7612 HOLLYWOOD ST

Mecklenburg County
Health Department

Re: 7612 Hollywood Street
File: 1551B
Parcel: 037-223-08PO

SOIL/SITE EVALUATION
for ON-SITE WASTEWATER SYSTEM

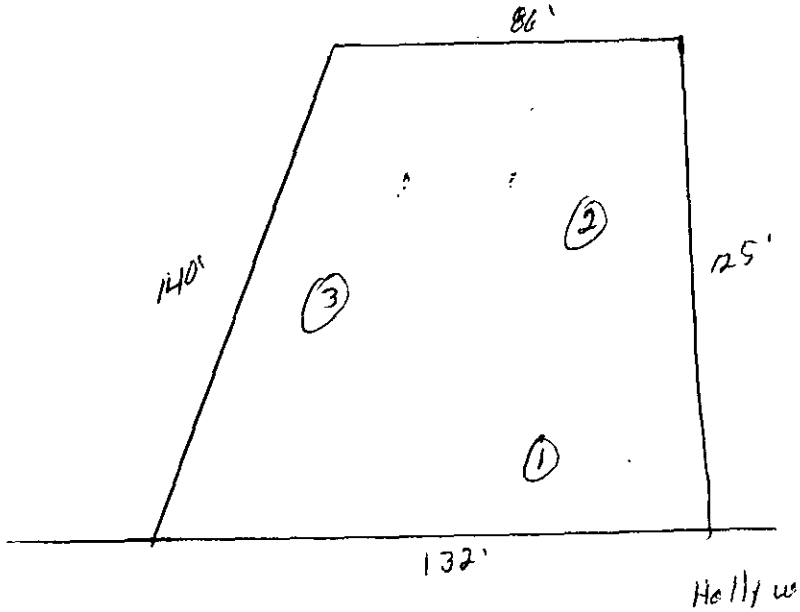
PROFILE #	3-6% slopes .1940 LANDSCAPE POSITION/ SLOPE %	HORIZON DEPTH (IN.)	SOIL MORPHOLOGY (.1941) .1941 STRUCTURE/ TEXTURE	.1941 CONSISTENCE/ MINERALOGY	OTHER PROFILE FACTORS .1942 SOIL WETNESS/ COLOR	.1943 SOIL DEPTH	.1956 SAPRO CLASS	.1944 RESTR HORIZ	PROFILE CLASS & LTA
1	LS	0-8"	gr/sc/	Fr/SEXP/SS/SP	2.5Y 7/1 @ 30-37"	37"	N/A	None	US
		8-37	sBK/C	Fr-Fi/SEXP/SS/SP					
2	LS	0-6"	gr/sc/	Fr/SEXP/SS/SP	2.5Y 7/1 @ 30"	40"	N/A	None	US
		6-28"	sBK/C	Fr-Fi/SEXP/SS/SP					
		28-40"	sBK/C	Fi/EXP/SS/P					
3	LS	0-8"	gr/sc/	Fr/SEXP/SS/SP	>33" TO Chroma 2 Colors	33"	N/A	None	US
		8-24"	sBK/SC	Fr-Fi/SEXP/SS/SP					
		24-33"	sBK/SC	Fi/EXP/SS/P					
4

OTHER FACTORS (.1946):
SITE CLASSIFICATION (.1948): recommended
EVALUATED BY: William A. Martin E-23

OMMENTS: Probably mound soil

SOIL/SITE EVALUATION
for ON-SITE WASTEWATER SYSTEM

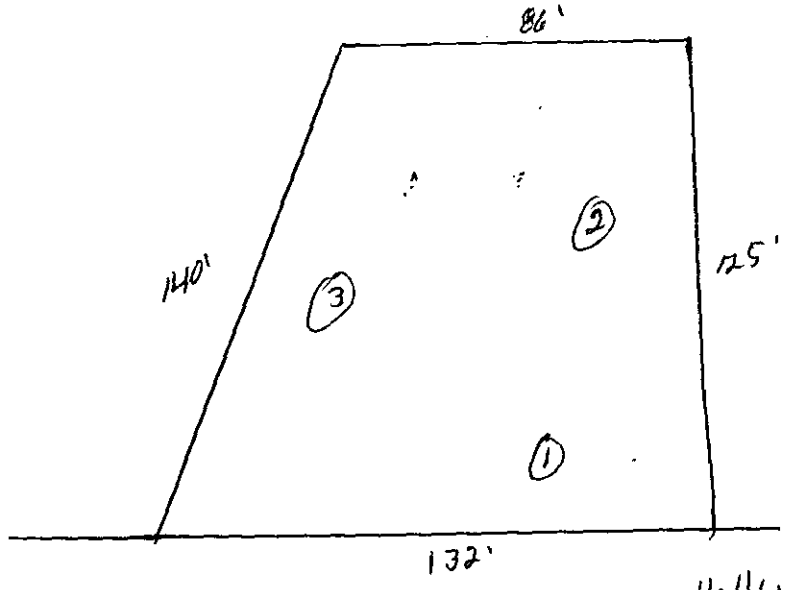
PROFILE #	3-6% 5 10-15 .1940 LANDSCAPE POSITION/ SLOPE %	HORIZON DEPTH (IN.)	SOIL MORPHOLOGY (.1941) .1941 STRUCTURE/ TEXTURE	.1941 CONSISTENCE/ MINERALOGY	OTHER PROFILE FACTORS .1942 SOIL WETNESS/ COLOR	.1943 SOIL DEPTH	.1956 SAPRO CLASS	.1944 RESTR HORIZ	PROFILE CLASS & LTAR
1	LS	0-8"	gr/sc/	Fv/SEXP/SS/SP	2.5Y 7/1 @ 30-37"	37"	N/A	None	US
		8-37	sBK/ C	Fr-Fi/SEXP/SP					
2	LS	0-6"	gr/sc/	Fr/SEXP/SS/SP	2.5Y 7/1 @ 30"	40"	N/A	None	US
		6-28"	sBK/ c	Fr-Fi/SEXP/SP					
		28-40"	sBK/ c	Fi/EXP/SP					
3	LS	0-8"	gr/sc/	Fv/SEXP/SS/SP	7 33" to chroma 2 colors	33"	N/A	None	US
		8-24"	sBK/sc	Fr-Fi/SEXP/SP					
		24-33"	sBK/sc	Fi/EXP/SP					
4

OTHER FACTORS (.1946):
SITE CLASSIFICATION (.1948): Versuleler
EVALUATED BY: William A. Mueller 8-23-96
OTHER(S) PRESENT:

OMMENTS: Probably would not be 100% Repair

SOIL/SITE EVALUATION
for ON-SITE WASTEWATER SYSTEM

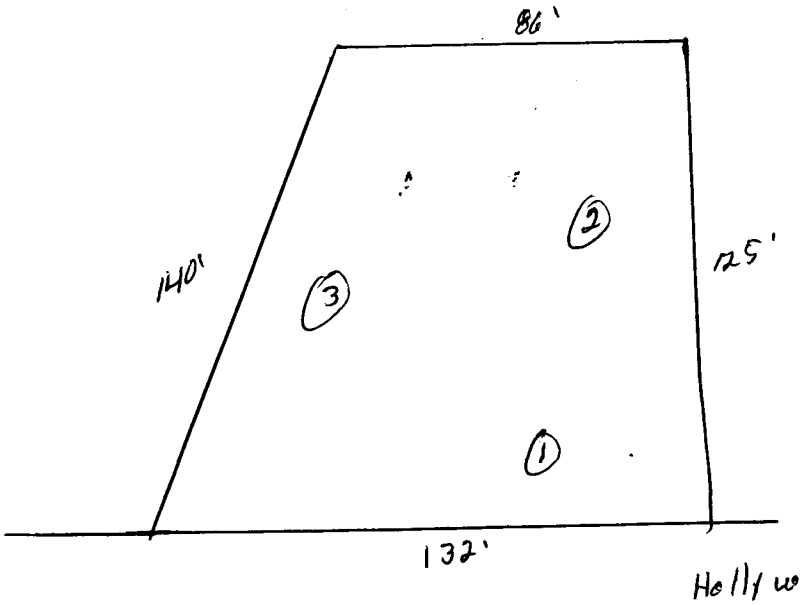
PROFILE #	.1940 LANDSCAPE POSITION/ SLOPE %	HORIZON DEPTH (IN.)	SOIL MORPHOLOGY (.1941) STRUCTURE/ TEXTURE	SOIL MORPHOLOGY (.1941) CONSISTENCE/ MINERALOGY	OTHER PROFILE FACTORS .1942 SOIL WETNESS/ COLOR	.1943 SOIL DEPTH	.1956 SAPRO CLASS	.1944 RESTR HORIZ	PROFILE CLASS & LTAR
1	LS	0-8"	gr/sc/	Fr/SEXP/SS/SP	2.5Y 7/1 @ 30-37"	37"	N/A	None	US
		8-37	sBK/ C	Fr-Fi/SEXP/SIP					
2	LS	0-6"	gr/sc/	Fr/SEXP/SS/SP	2.5Y 7/1 @ 30"	40"	N/A	None	US
		6-28"	sBK/ c	Fr-Fi/SEXP/SIP					
		28-40"	sBK/ c	Fi/EXP/SIP					
3	LS	0-8"	gr/sc/	Fr/SEXP/SS/SP	>33" TO chroma 2 colors	33"	N/A	None	US
		8-24"	sBK/sc	Fr-Fi/SEXP/SIP					
		24-33"	sBK/sc	Fi/EXP/SIP					
4

OTHER FACTORS (.1946):
SITE CLASSIFICATION (.1948): Versuleler
EVALUATED BY: William A. Meuli 8-23-96
OTHER(S) PRESENT:

OMMENTS: Probably would not be 100% Repair
